SUBJECT: Forwards open items from Structural Engineering Branch
 811005-08 meeting in Woodbury, NY.

Subject: NUCLEAR PROJECT NO. 2
OPEN ITEMS FROM SEB MEETING

Attached are sixty copies of the open items from the Structural Engineering Branch meeting held in Woodbury, New York, October 5 - 8, 1981.

WNP-2
NRC-SEB MEETING

EIGENVECTOR No. = 17
NATURAL FREQ. = 9.70 Hz

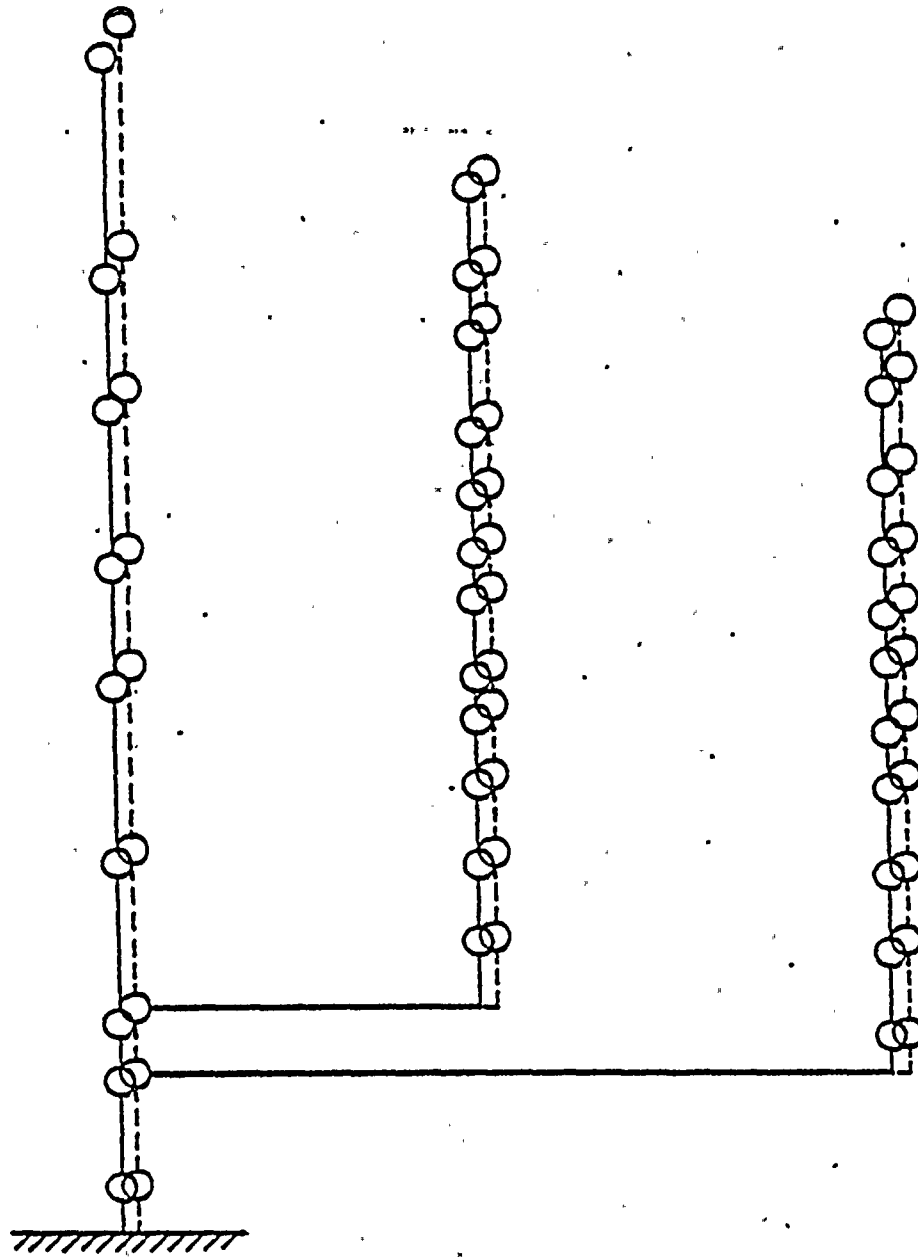
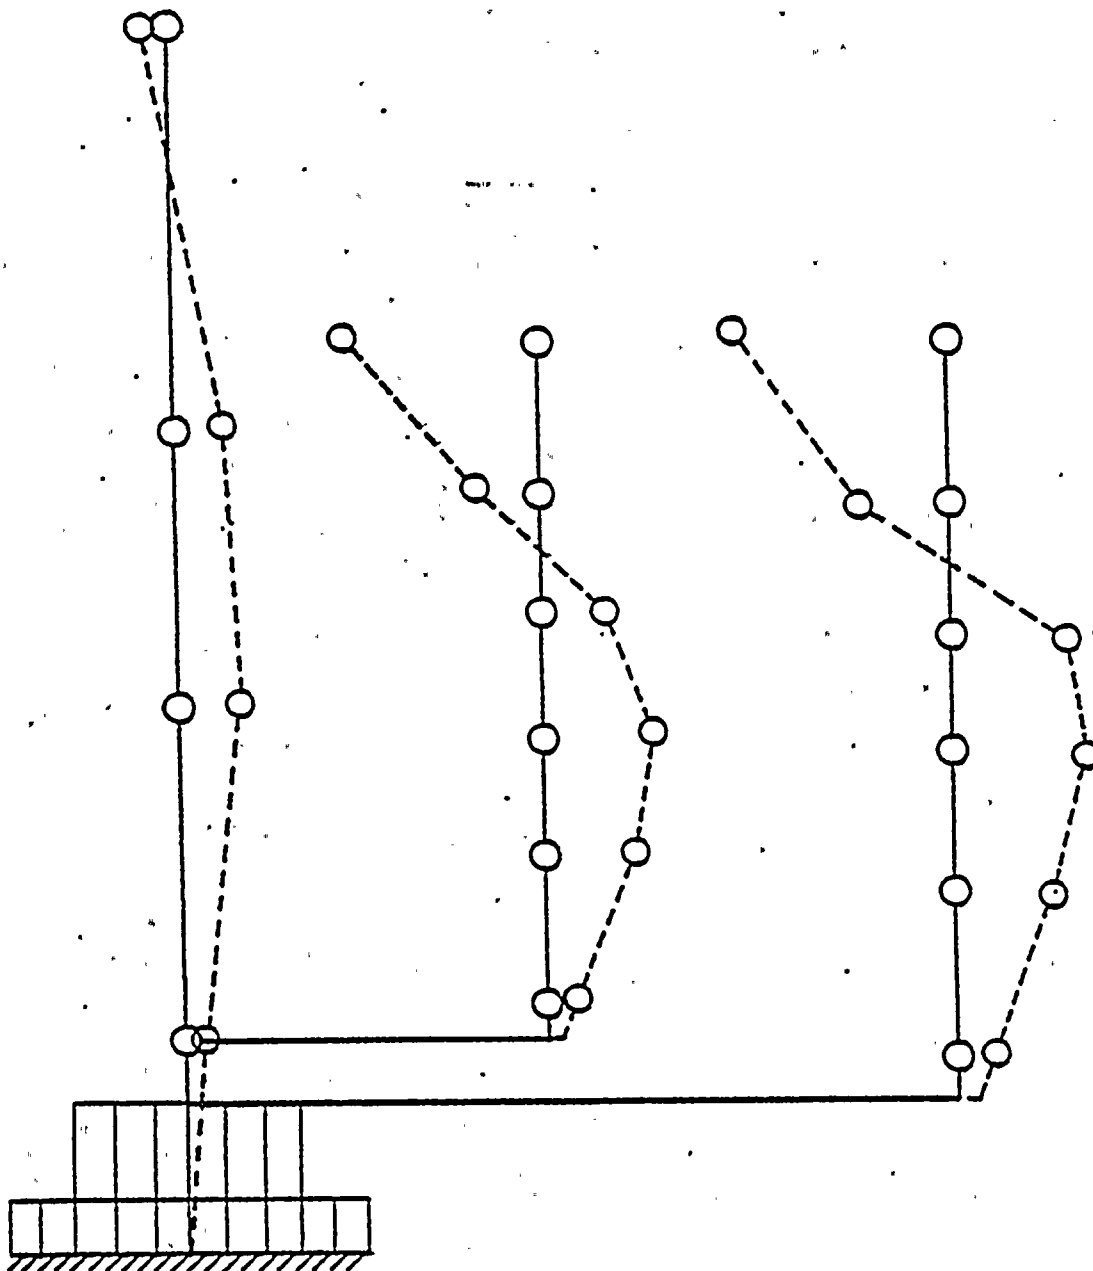
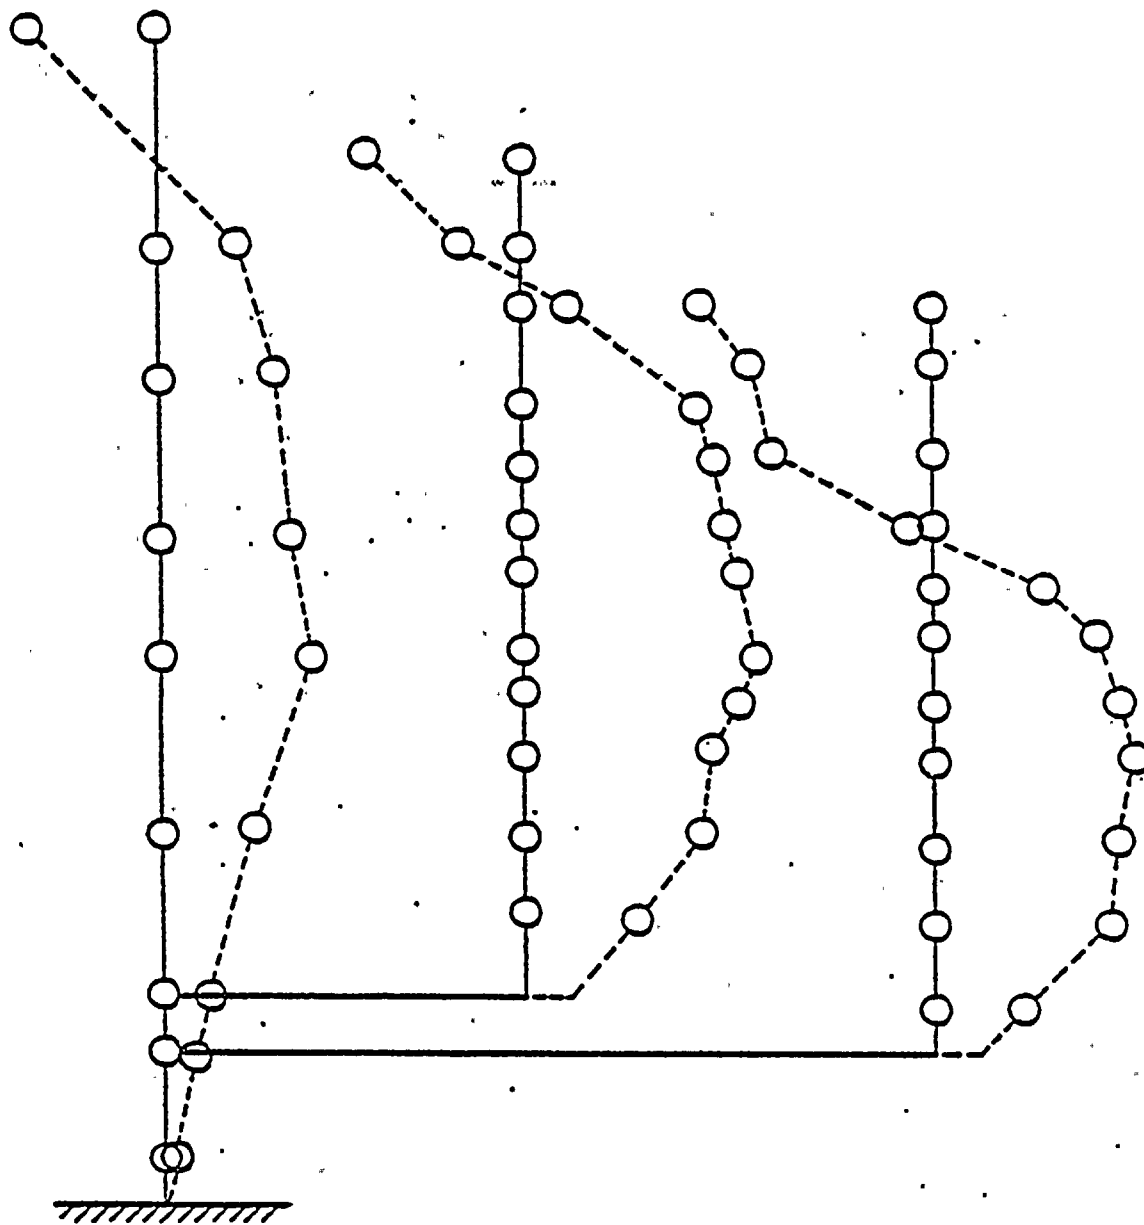
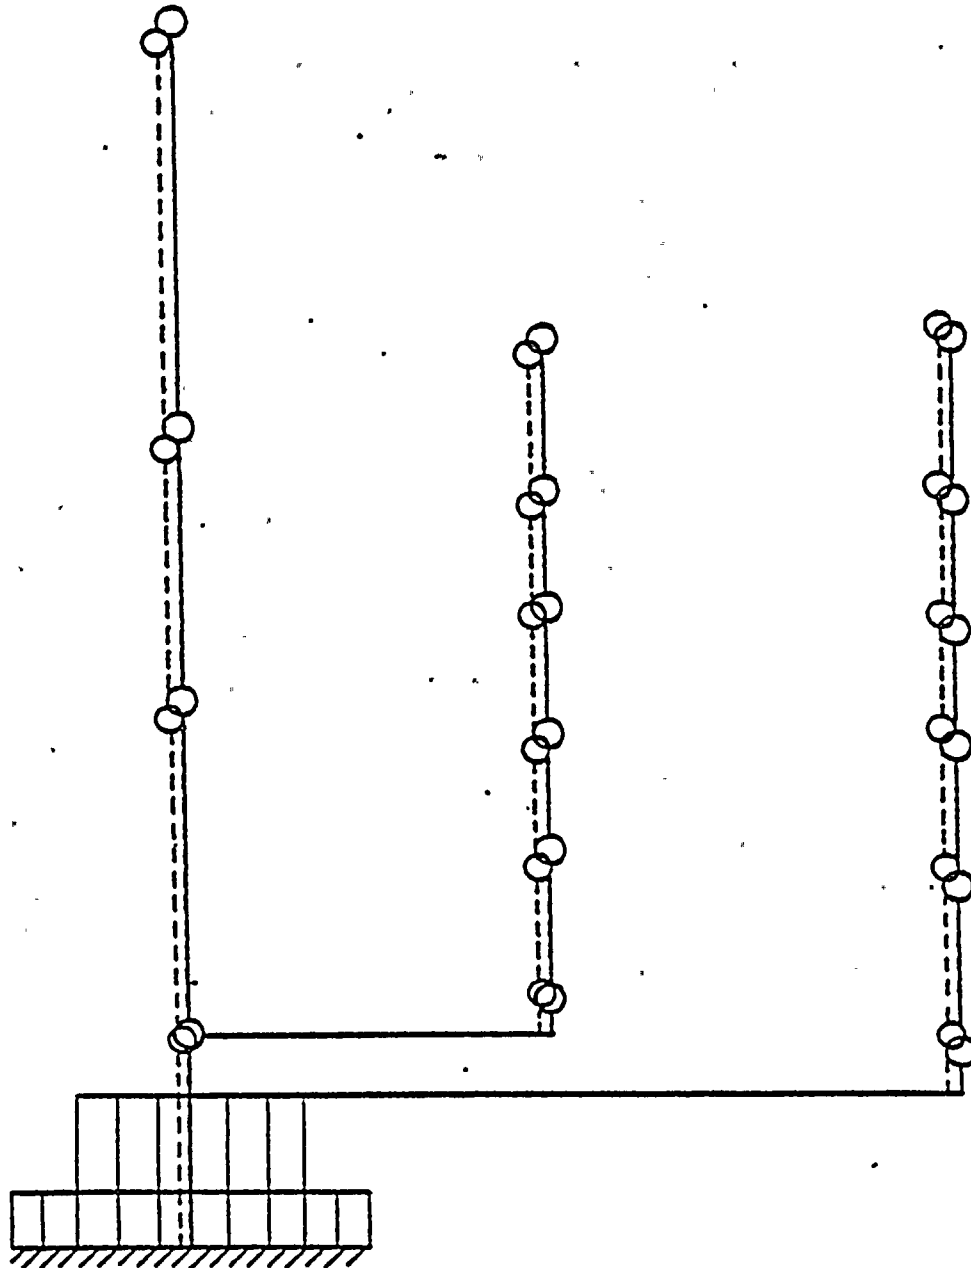
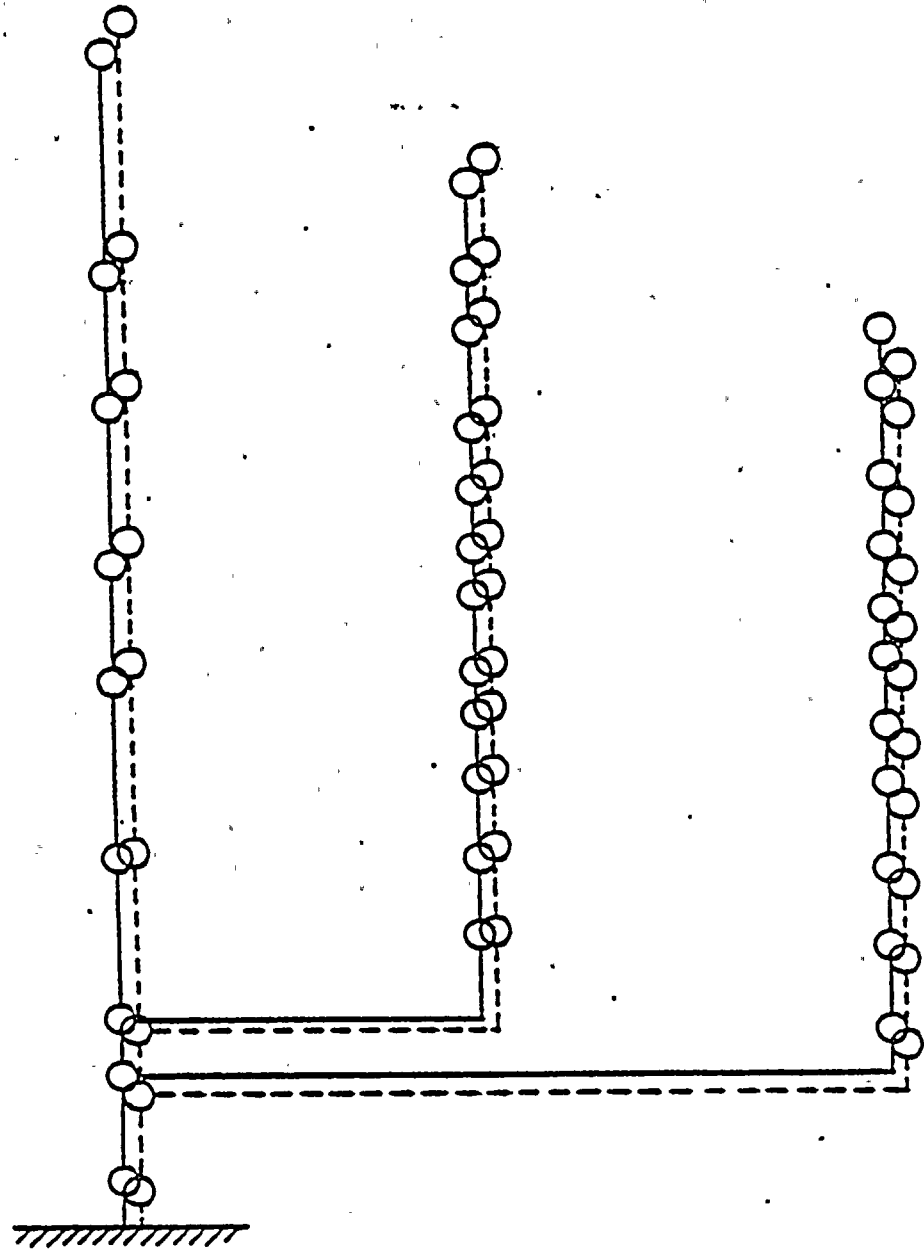
RESPONSE

The reduced (simplified) and full models of the reactor building are shown in the figures attached. An eigen value solution was obtained for each model and corresponding natural frequencies and natural mode shapes are compared. The good agreement noted indicates the equivalence of the two models for the reactor building.

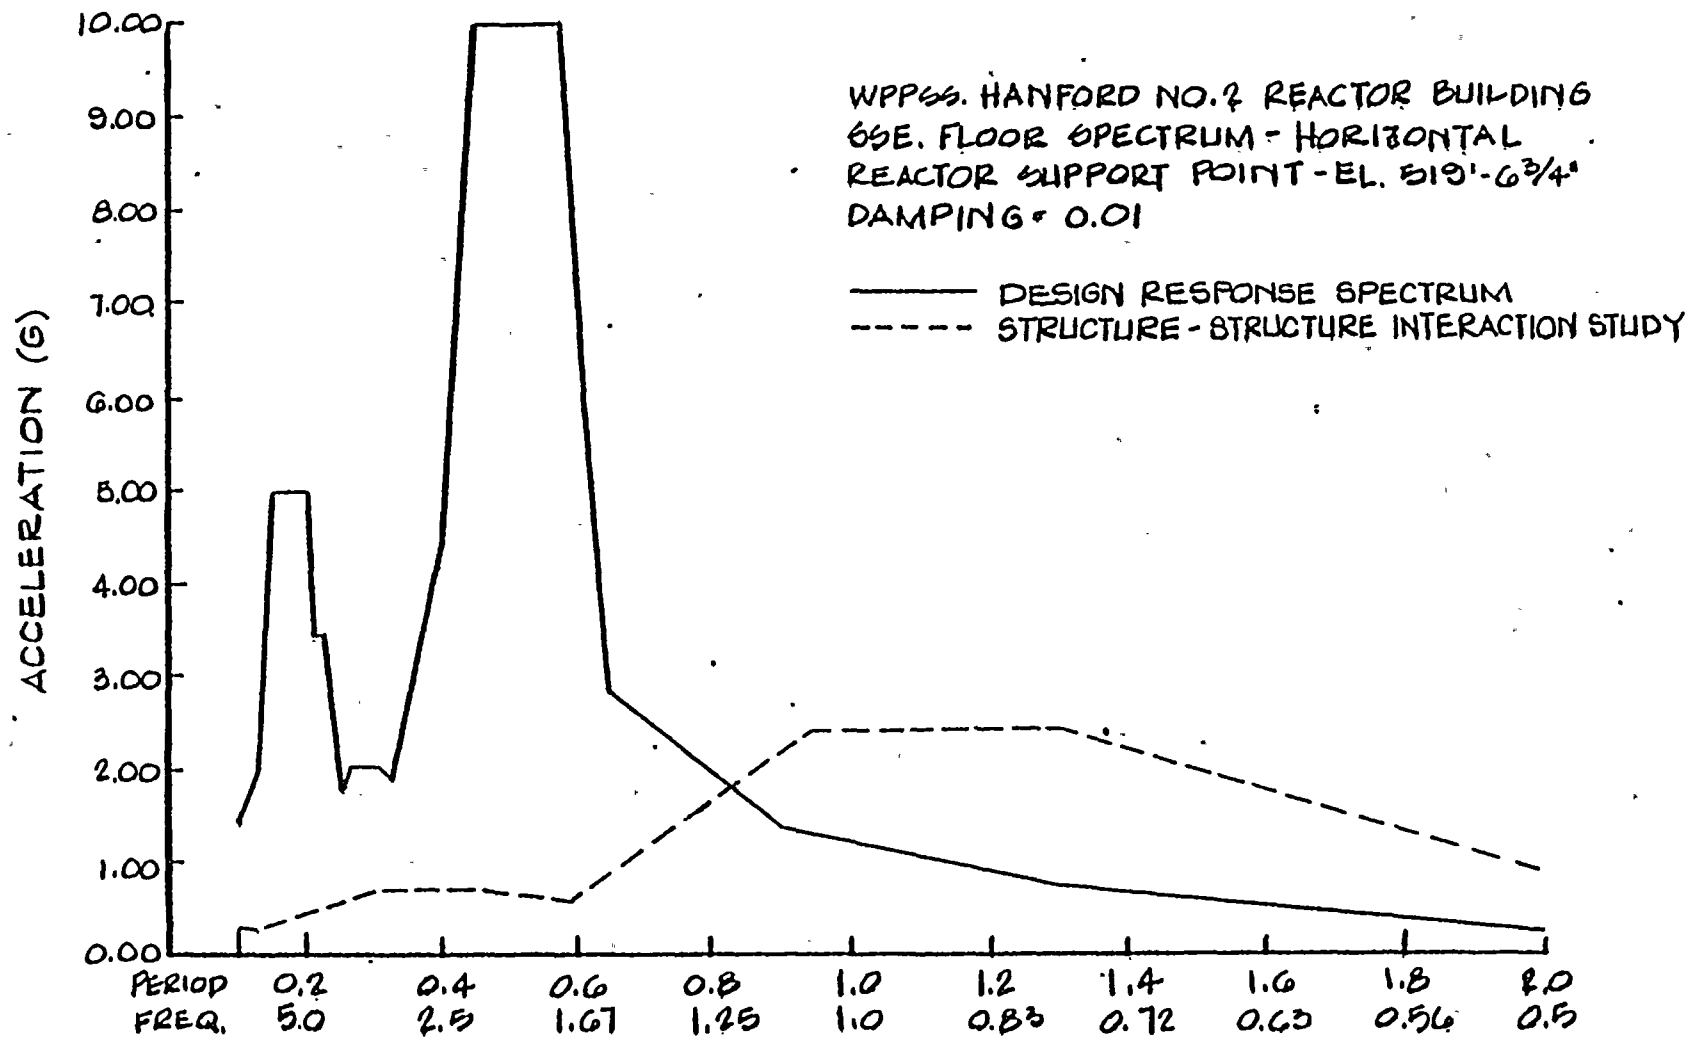
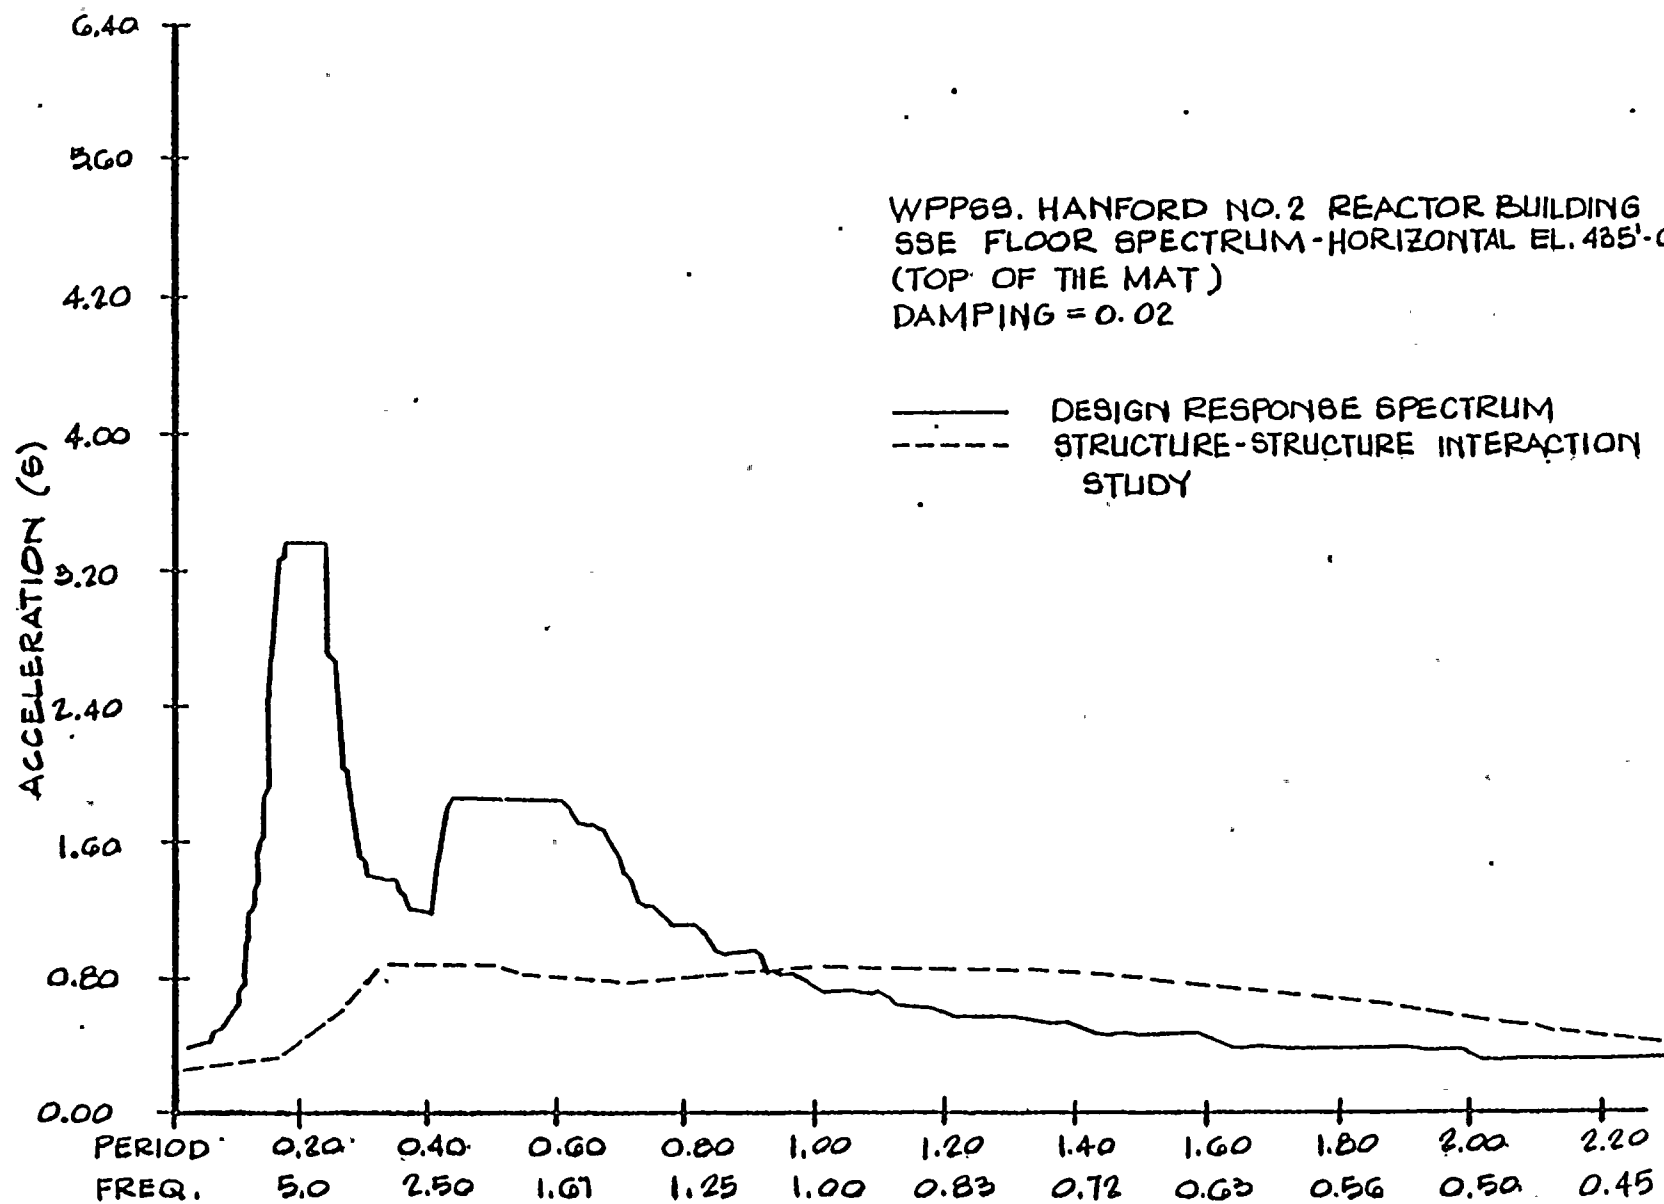
Confirm that the design response spectra used for the RPV support and basemat are higher than those obtained in the structure/structure interaction study.

The attached figures show that the design response spectra at the RPV support and basemat are higher than those obtained in the structure/structure interaction study at all frequencies of concern (higher than 1.0 Hz approx.).
